R.T.I. ADDITION

Re: S/D 96-54 - R.T.I. ADDITION (Final Plat)

STAFF REPORT
(Final Plat Approved 8/22/96)

CASE NUMBER: S/D 96-54 R.T.I. ADDITION

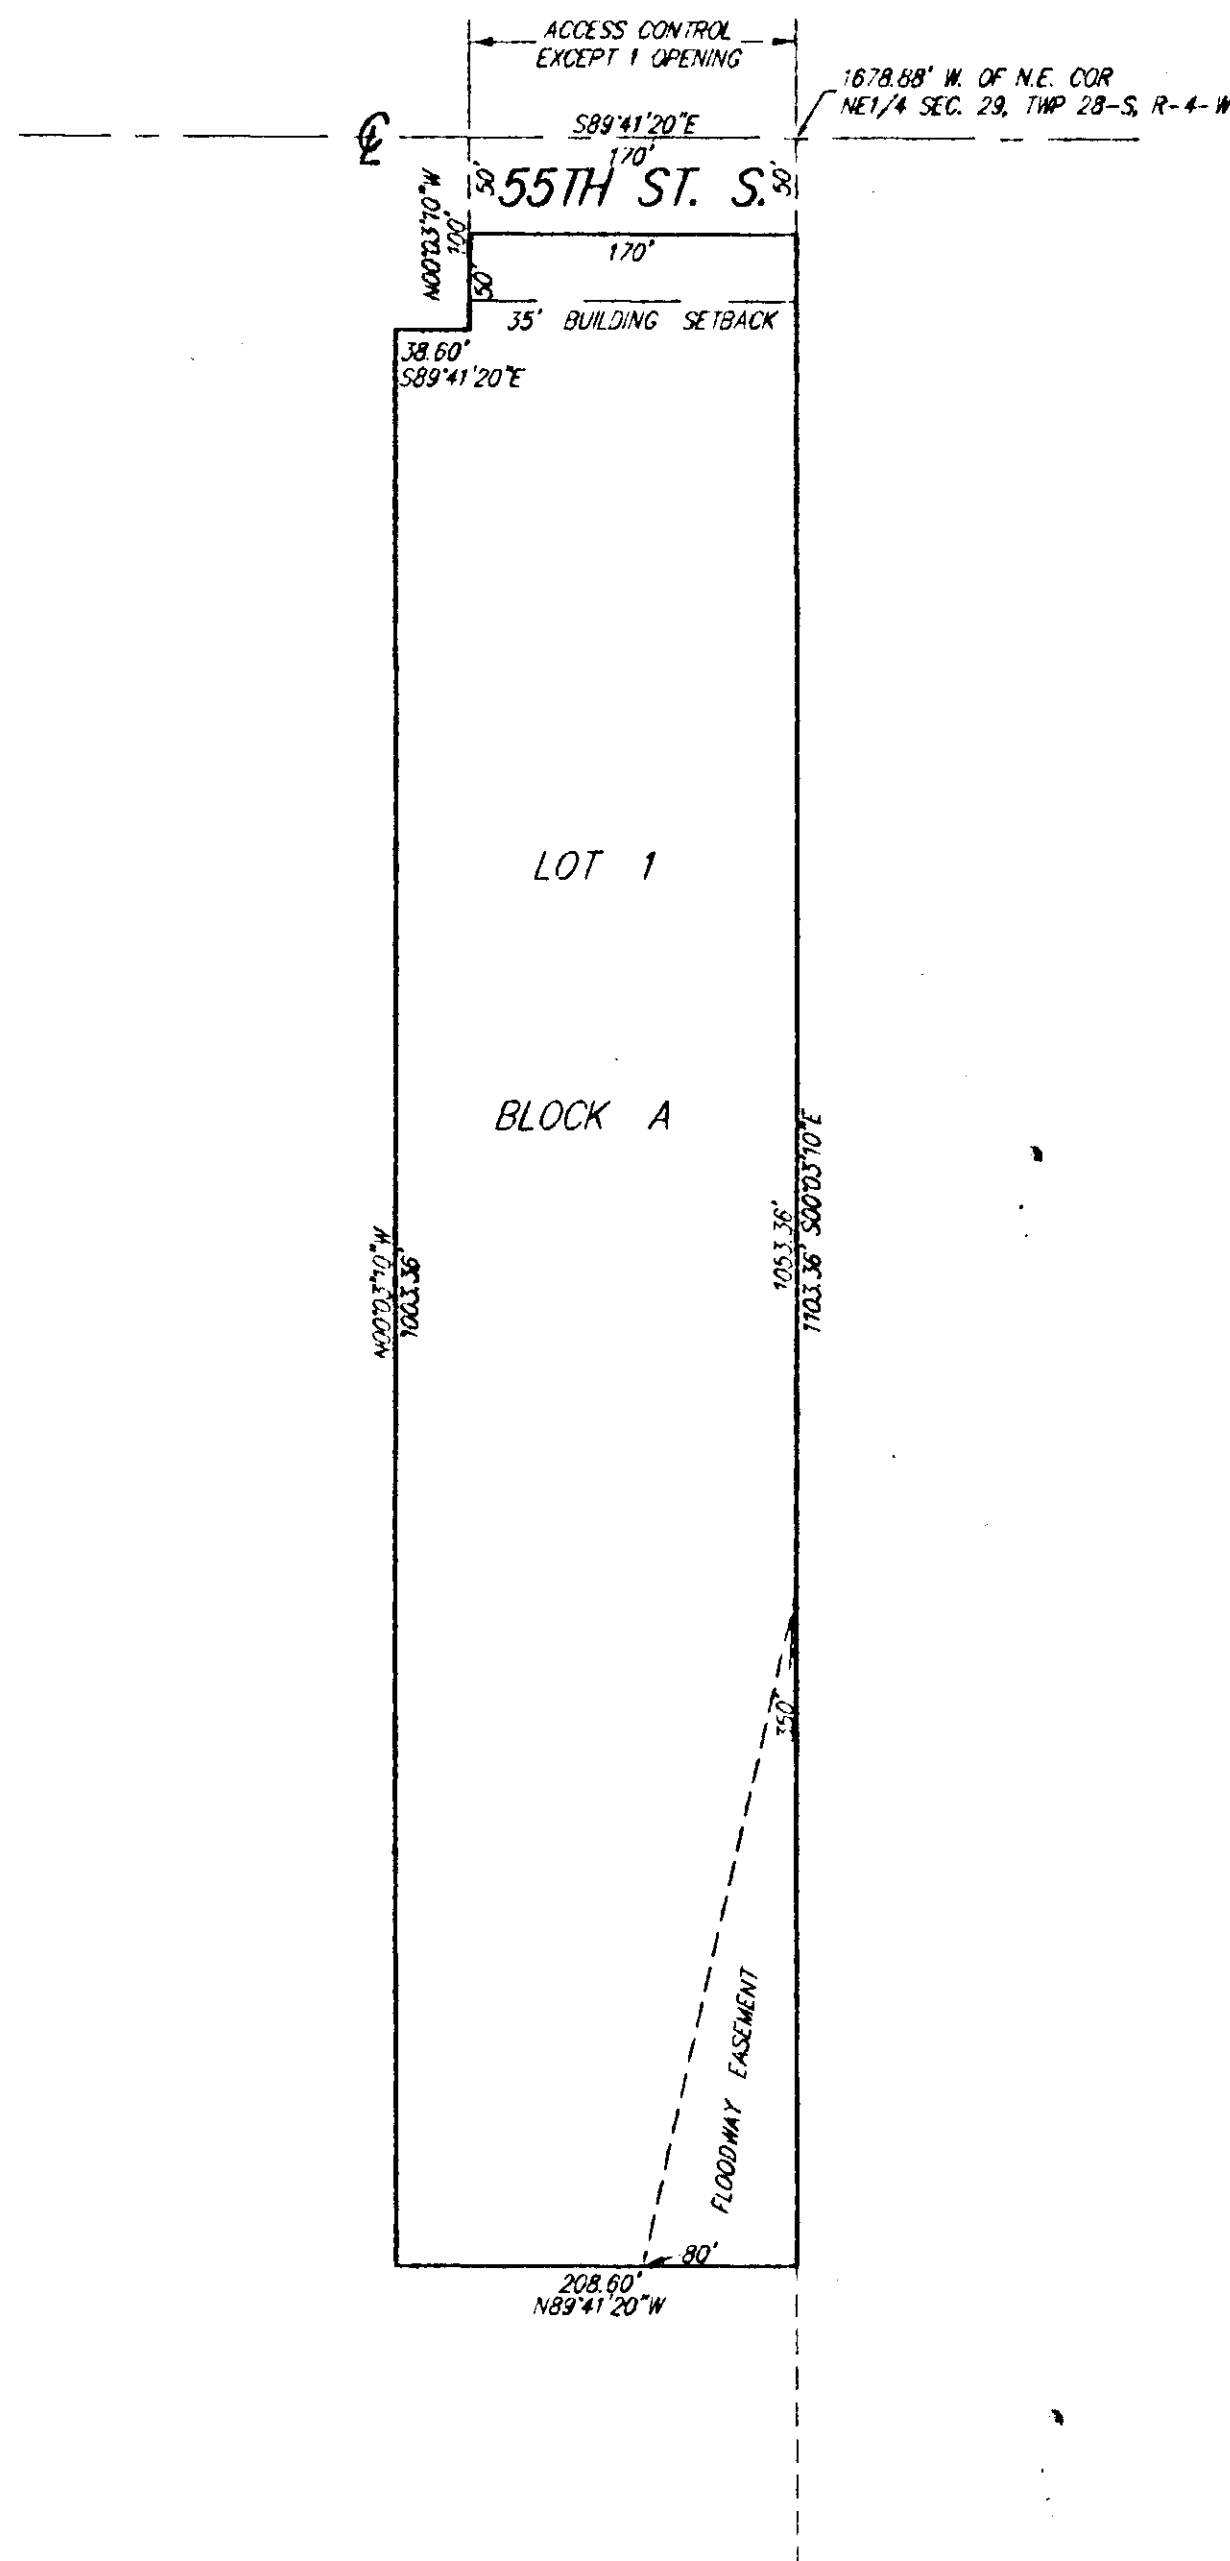
- B. The applicant shall guarantee any drainage improvements required by the platting of this property.
- C. Based on the existence of a floodway on this site, County Engineering is requiring a minimum building elevation of 1,343'. Such elevation shall be noted both in the plat's text and on the face of the plat. Also, both an on-site and off-site benchmark shall be shown.

- D. In regard to the floodway, County Engineering indicated the involved area of this lot should be shown as a Floodway Reserve.
- E. It should be noted that for non-residential lots, the lot depth to width standard of 2 1/2:1 does not apply.
